BAMx Comments on the CAISO's White Paper on the Transmission Capability Estimates as an input to the CPUC Integrated Resource Plan Portfolio Development

Attachment A: Excerpts from the BAMx comments on the CAISO 2018-19 Transmission Plan, dated November 30, 2018

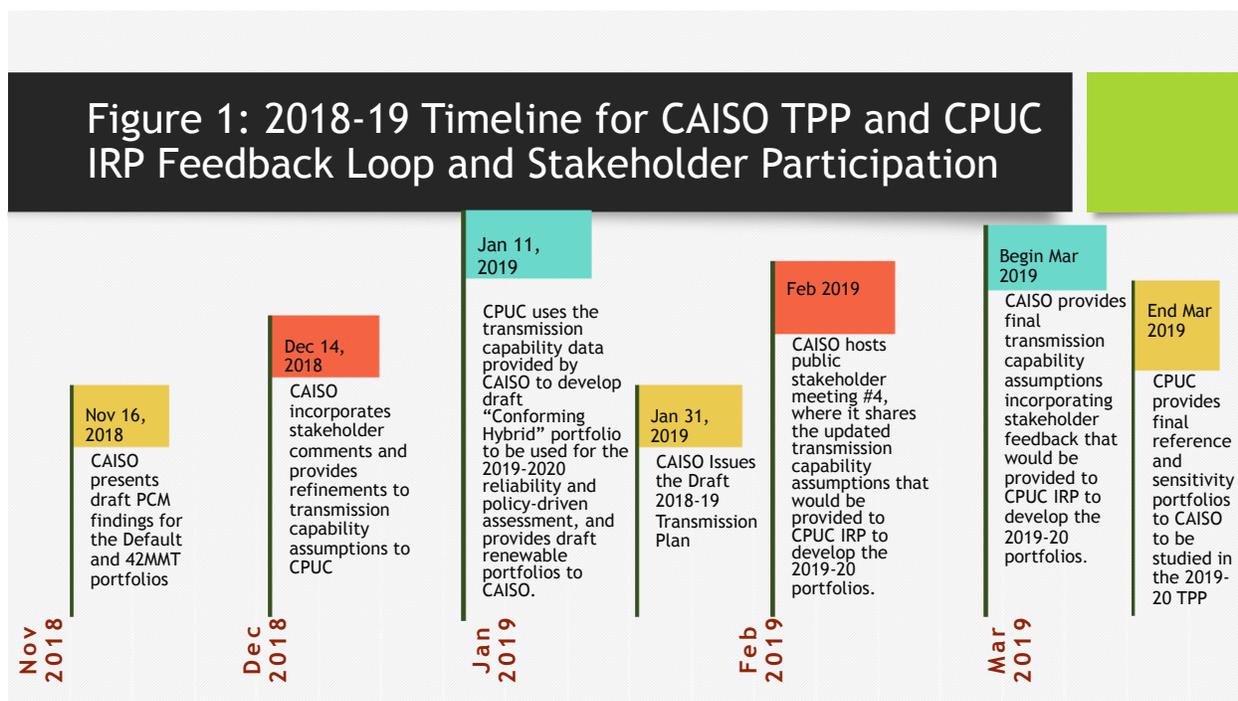
In Figure 1 below, we suggest a timeline for CAISO's consideration entailing an exchange of data and information among CAISO TPP, CPUC IRP, and involved stakeholders. In particular, we request the CAISO to provide its draft transmission capability estimates to the CPUC's IRP comprising the stakeholder feedback in mid-December 2018. This would allow the CPUC adequate time to include those estimates in the RESOLVE model and provide the resulting draft "Conforming Hybrid" resource portfolio - to be used in the 2019-2020 reliability and policy-driven assessment - to the CAISO by mid-January 2019.

The CAISO could then utilize its updated Production Cost Modeling (PCM) analysis⁸ and the CPUC's draft portfolios to further refine the transmission capability estimates, and present it during the February 2019 stakeholder meeting. Subsequently, the CAISO would then incorporate the stakeholder feedback in the "final" transmission capability estimates it would provide to the CPUC beginning of March 2019. This would provide CPUC with adequate time for developing and providing the final base (reference) and sensitivity portfolios for the 2019-2020 TPP.

The above BAMx-proposed timeline will ensure that the 2019-20 TPP portfolios used to determine the reliability and policy-driven projects are vetted by stakeholders and would minimize the likelihood any inefficient and unneeded Area Delivery Network Upgrades (ADNU)⁹ being approved under the 2019-2020 TPP. If for some reason, the CAISO and CPUC cannot implement the feedback loops outlined in Figure 1, we suggest the timeline shown in Figure 2 during the 2019-20 TPP.
